**Report to the Future Melbourne (Planning) Committee**

**Ministerial Referral: ID-2016-3 (Amendment GC44)  
Melbourne Convention and Exhibition Centre  
2-26 Clarendon Street, South Wharf**

### MINISTERIAL REFERRAL

<b>Application number:</b>	<b>ID-2016-3</b>
<b>DELWP Application number:</b>	<b>MBR029290 - Amendment GC44</b>
<b>Applicant / Owner / Architect:</b>	Urbis Pty Ltd / Plenary Group Pty Ltd / NH Architecture and Woods Bagot
<b>Address:</b>	Melbourne Convention Exhibition Centre, 2-26 Clarendon Street, SOUTH WHARF VIC 3006
<b>Proposal:</b>	Stage 2 of Melbourne Convention and Exhibition Centre - expansion of convention centre, new hotel and carpark
<b>Date received by Melbourne City Council:</b>	14 April 2016
<b>Responsible officer:</b>	Kate Yuncken
<b>Report Date:</b>	28 April 2016

PEDESTRIAN LINK ILLUSTRATIVE PLAN

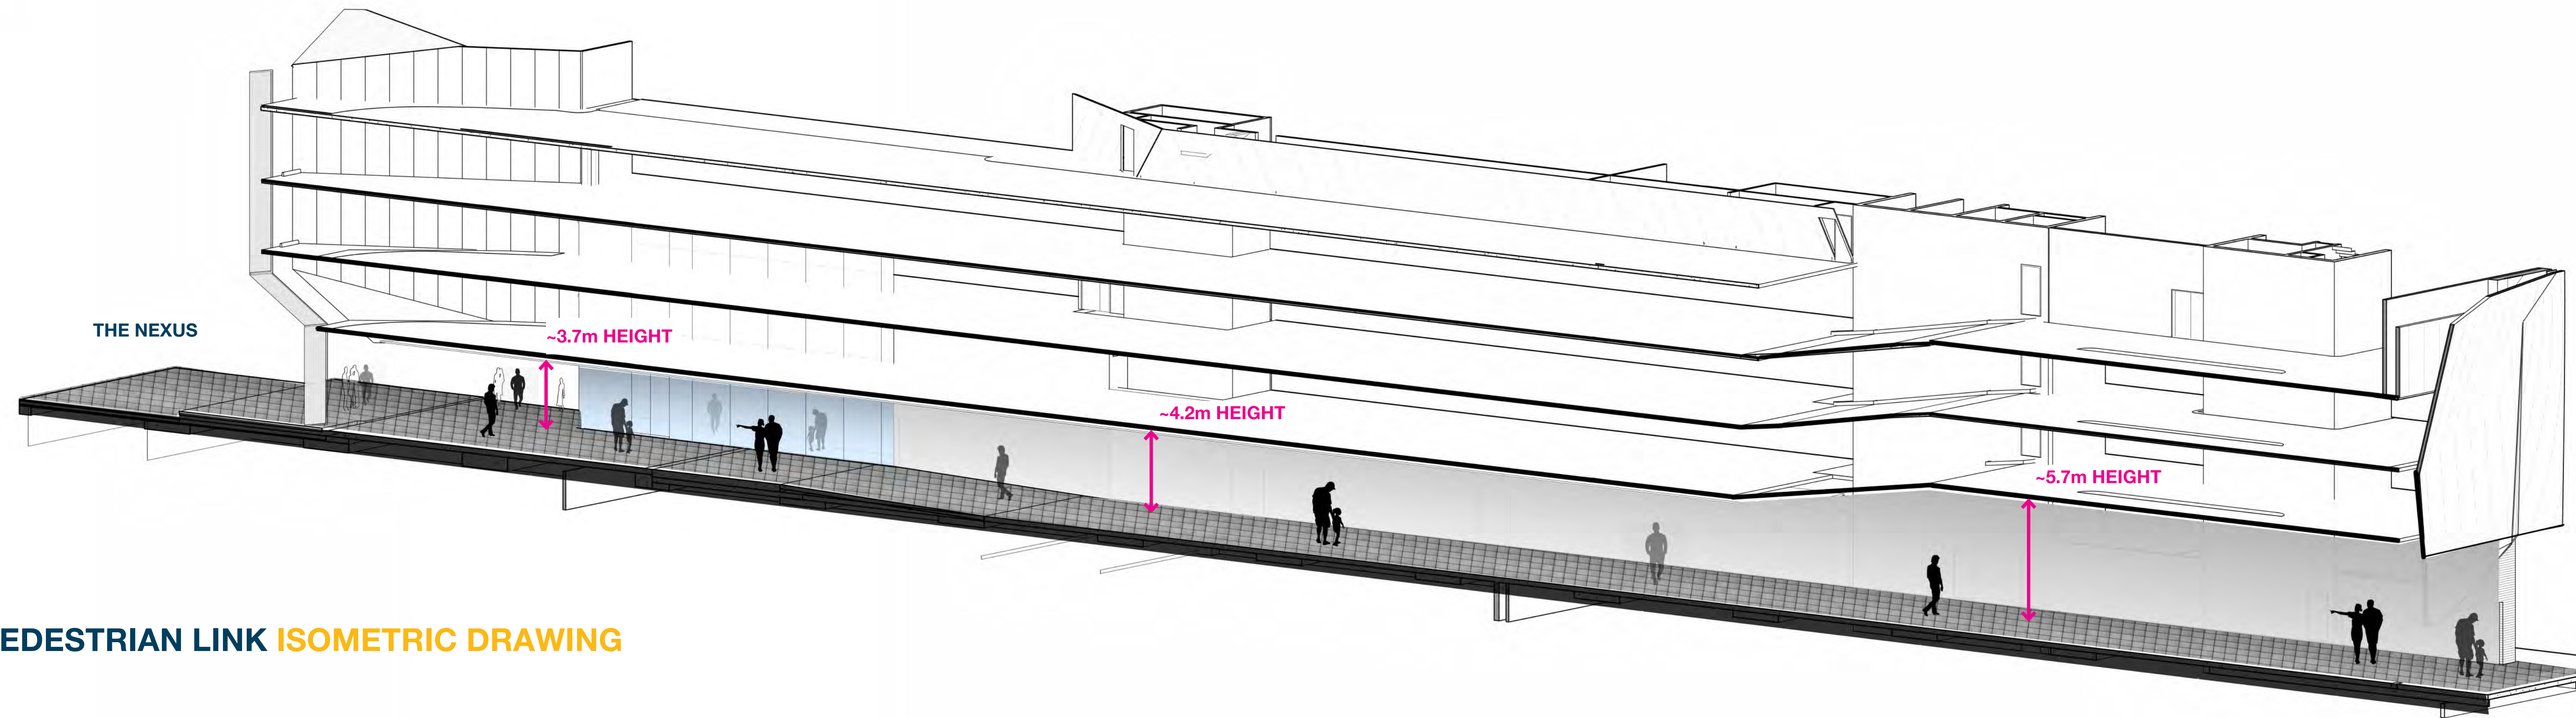
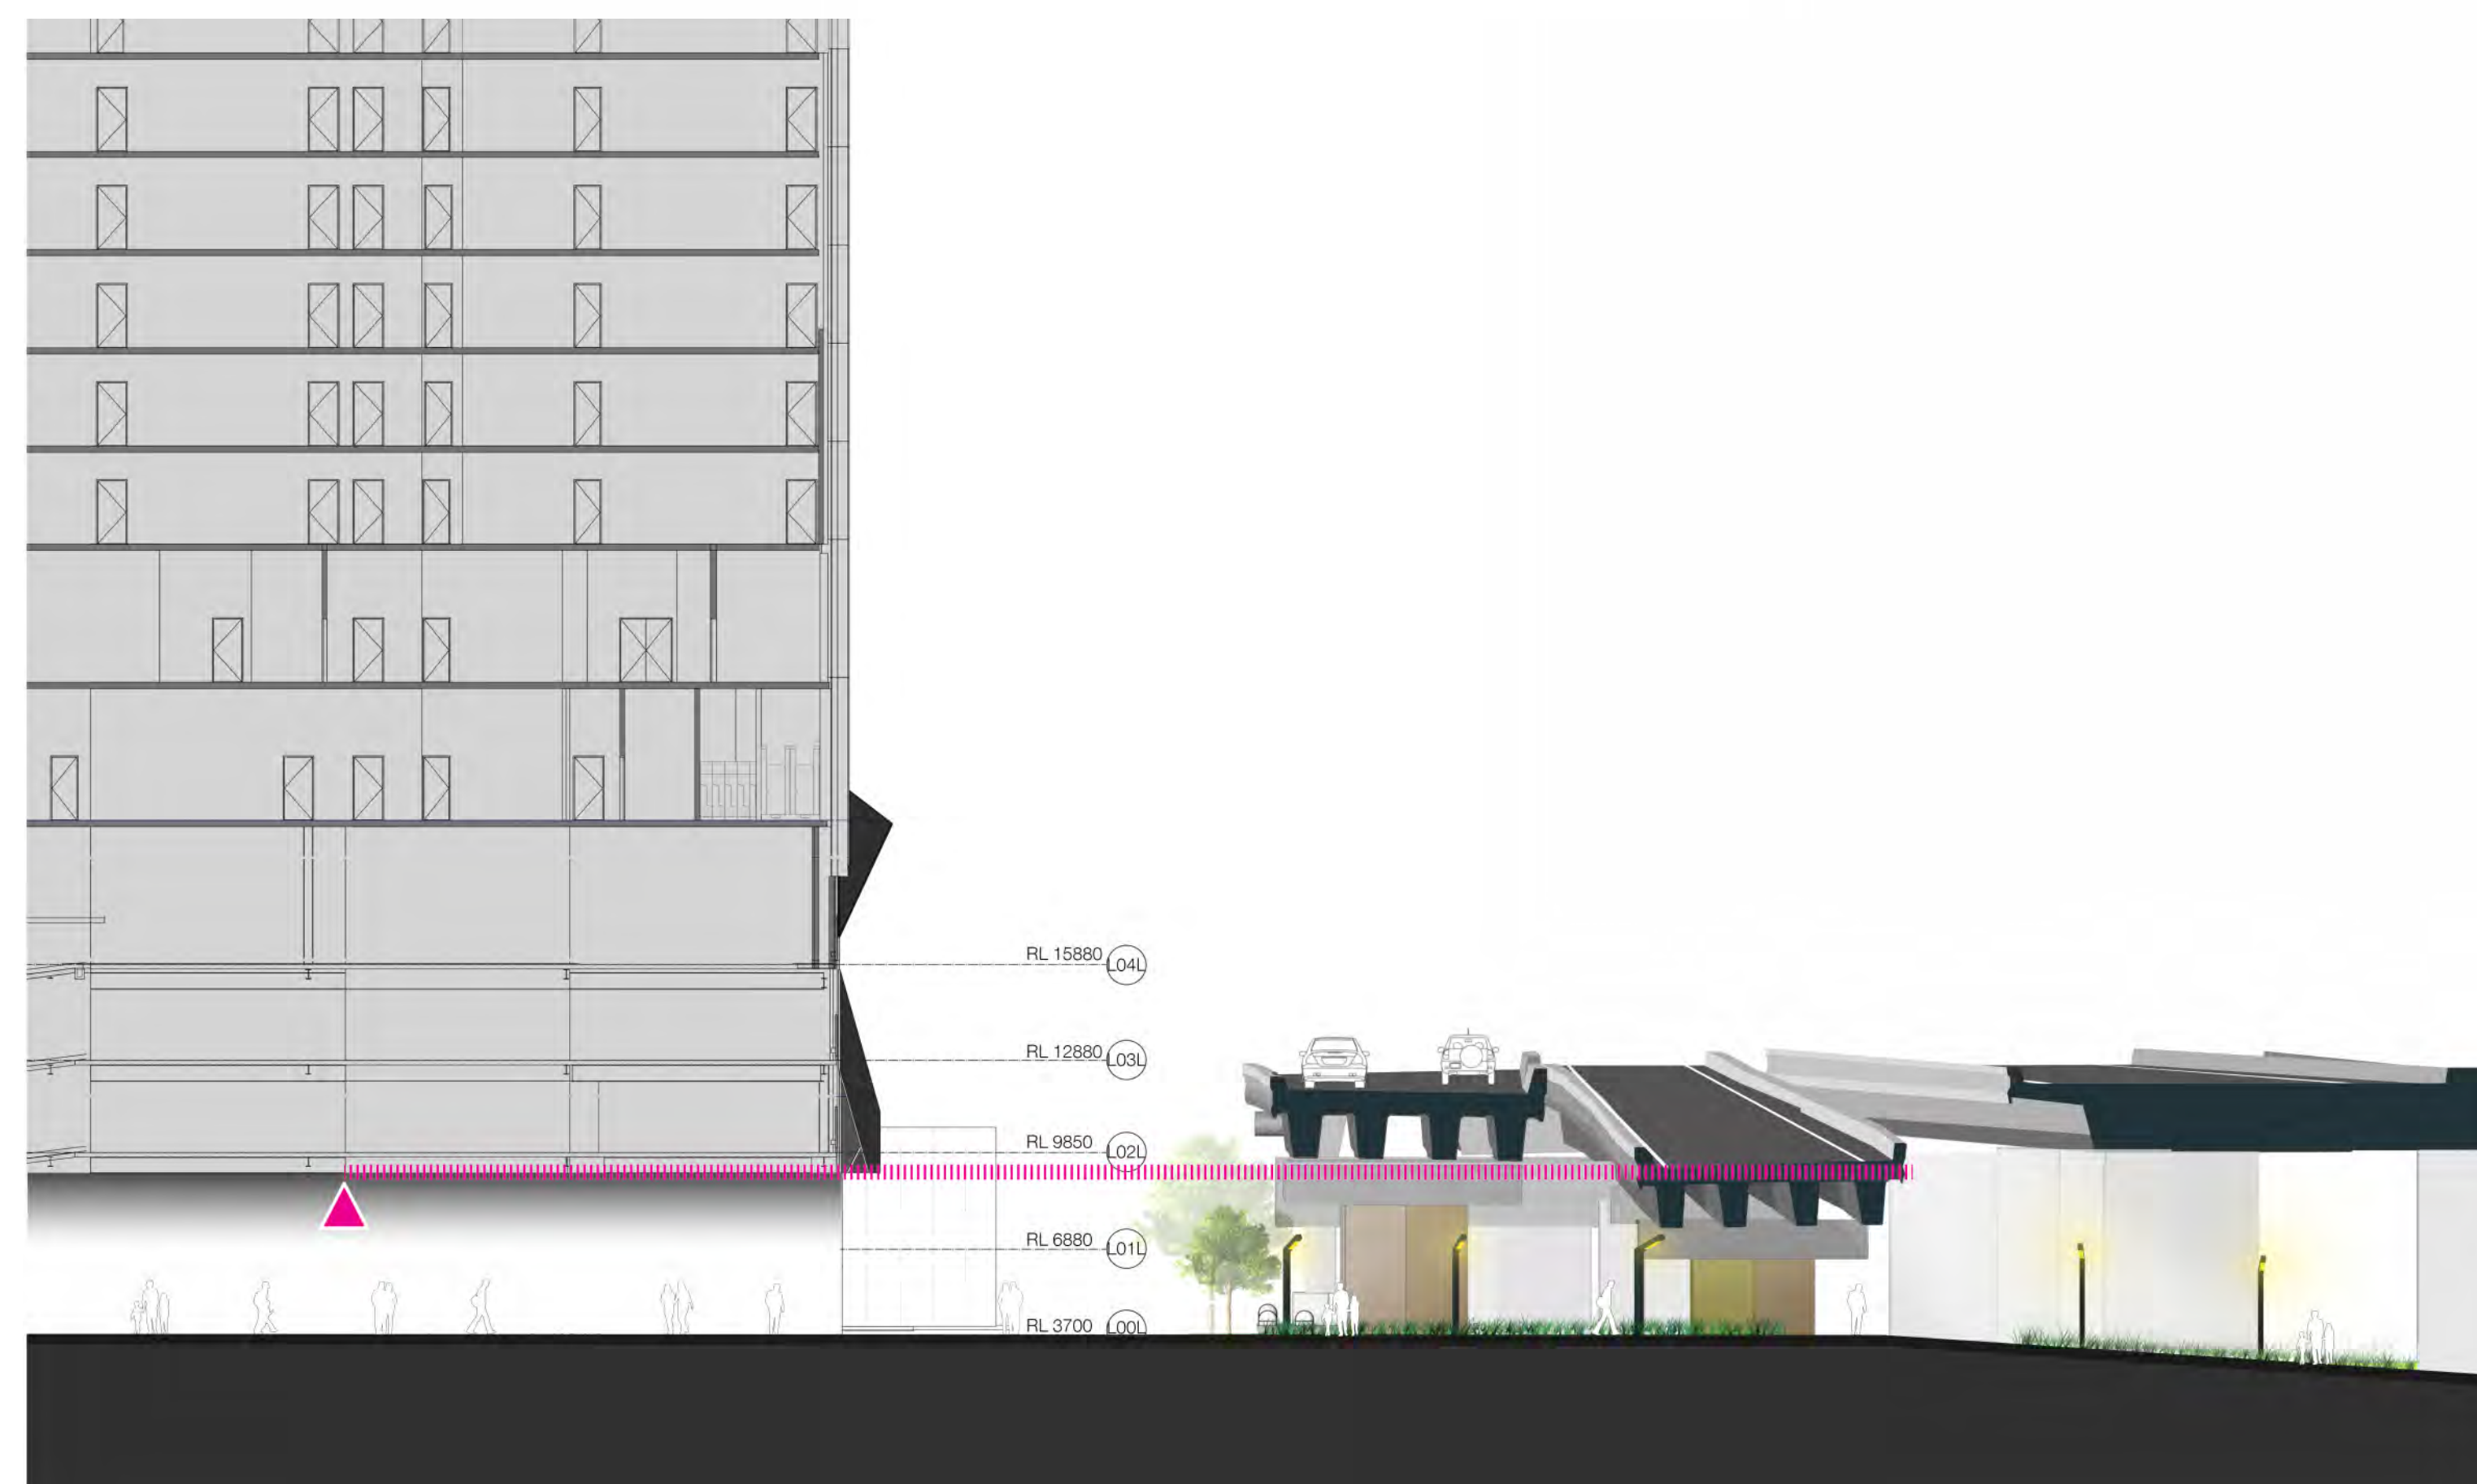
Several concerns have been raised by both the Urban Design and City Design team in regard to the north-south ground level pedestrian link that is bounded by the Exhibition Hall and Hotel on one side and the new multi-storey car park on the other. Concerns of safety, narrowness of the link, blind spots (poor sightlines) and attractiveness were raised and passed onto the applicant.

The revised ground floor pedestrian link is considered to be a significant improvement on the originally proposed link resulting in a safer, more attractive and active space. It is noted that the space has not however been completely resolved to date and that the modifications shown in the plans prepared by NH Architecture and Woods Bagot dated May 2016 and the detailed resolution of the link will be

- Increase the clearance height of the north entrance of the pedestrian link by removal of built form on level 2 to improve daylight penetration and legibility of the pedestrian link to the satisfaction of the Responsible Authority. This may require the deletion of the first 9 car spaces and associated built form above this space (to match or be similar to level 1 of the car park).

- The through block link has been widened to 7 metres and the ceiling heights have been increased to provide heights ranging from 3.7 metres to 5.5 metres.
- The detailing of the northern and southern entries to the link have been enhanced to create generous portals highlighting the entry points.
- The hotel has been moved 1.6 m further to the east to enable the provision of a straight link through the building.

- Further the detailed resolution of the pedestrian link to the satisfaction of the Responsible Authority.
- A wayfinding strategy for cyclists to be prepared and endorsed for all the proposed buildings to the satisfaction of the Responsible Authority. Façade Strategy and Materials Schedule must demonstrate that built form, materials and finishes are of a high design quality.
